What the NWTRB should do about INL's "Steam Reforming" Boondoggle*

Darryl D. Siemer, PhD

6Aug2014

Pre-decisional depiction of “steam reforming”^{note}

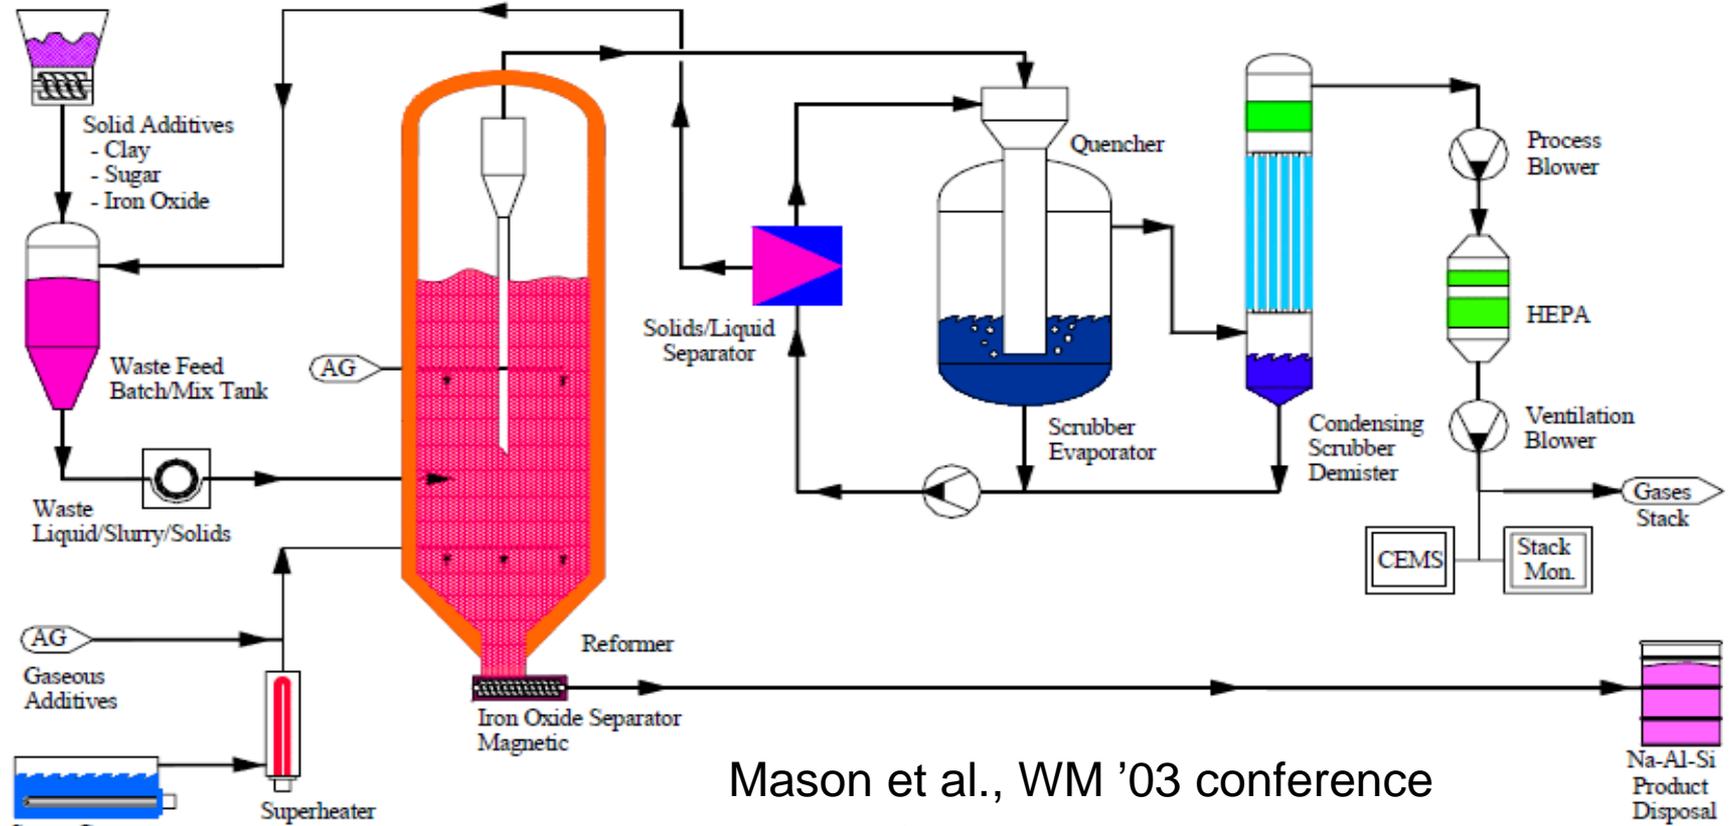
- Note that it didn't produce “fines” (i.e., depicts 100% fines recycle – impossible)
- “It can produce ... silicate, or aluminosilicate products” - not true

Current depiction of “steam reforming”

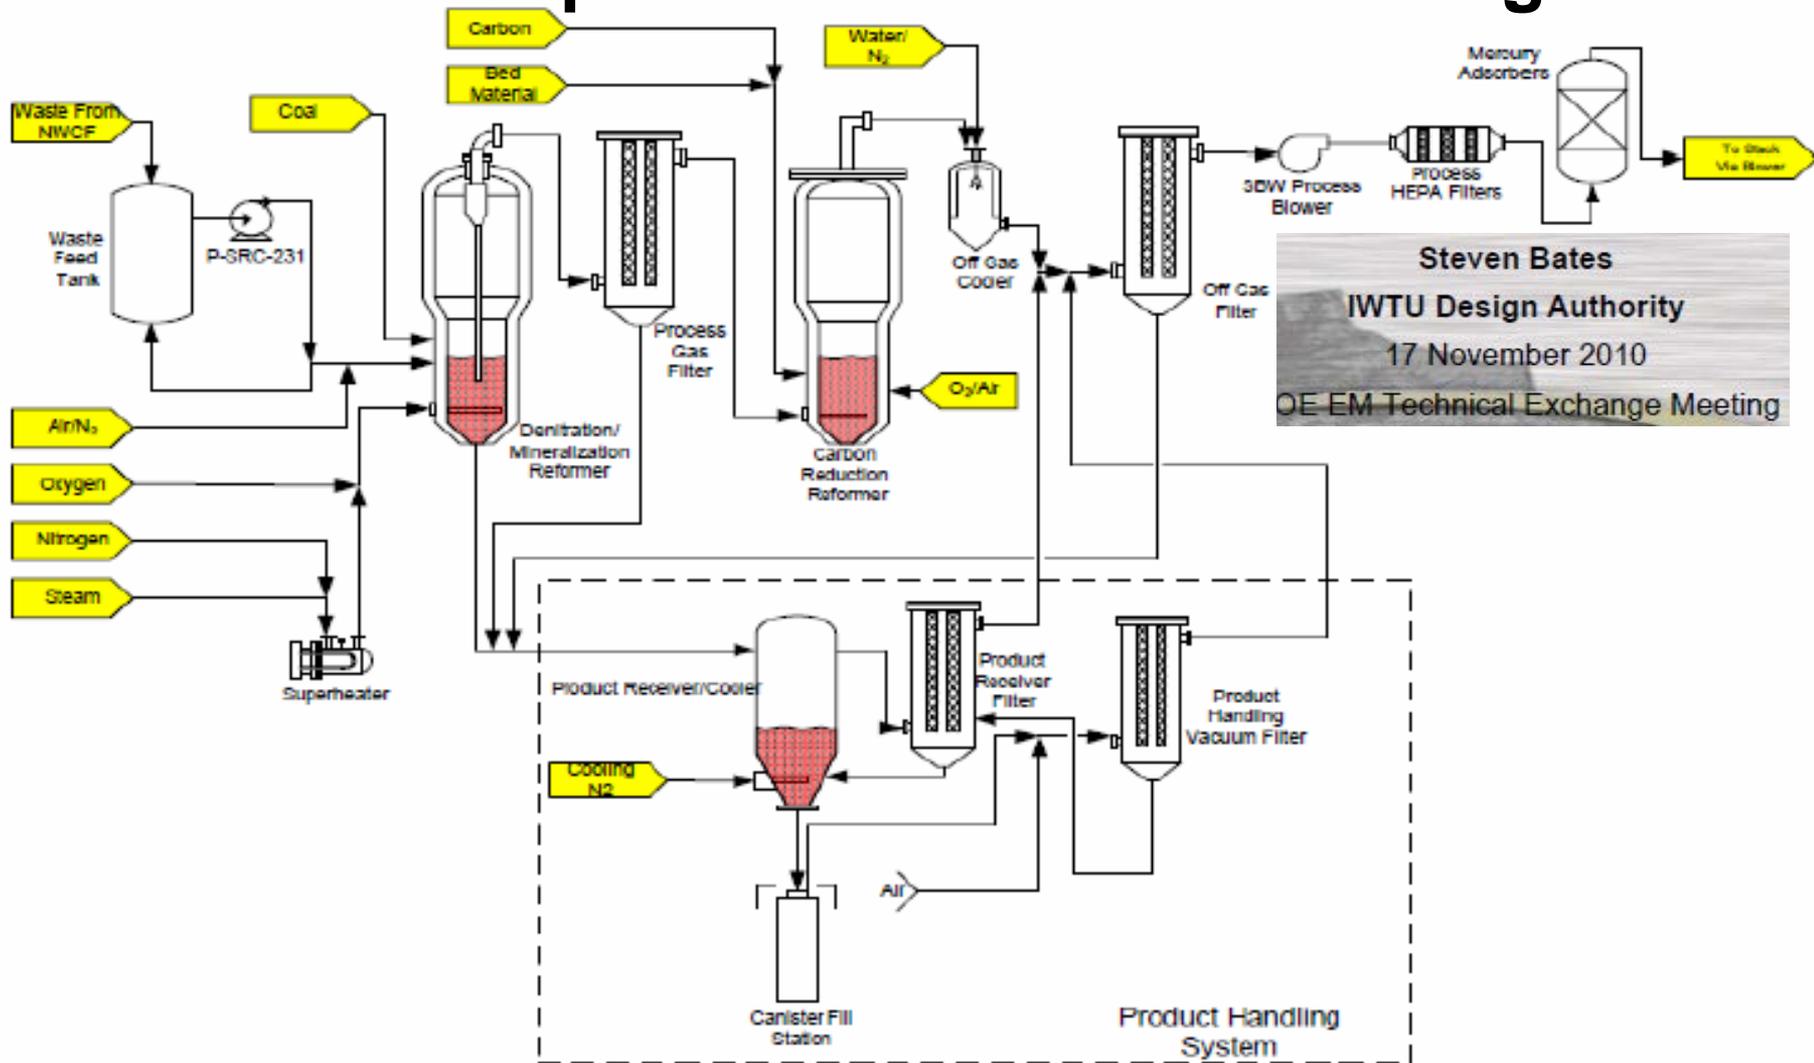
Note that fines are to end up in “product” canisters
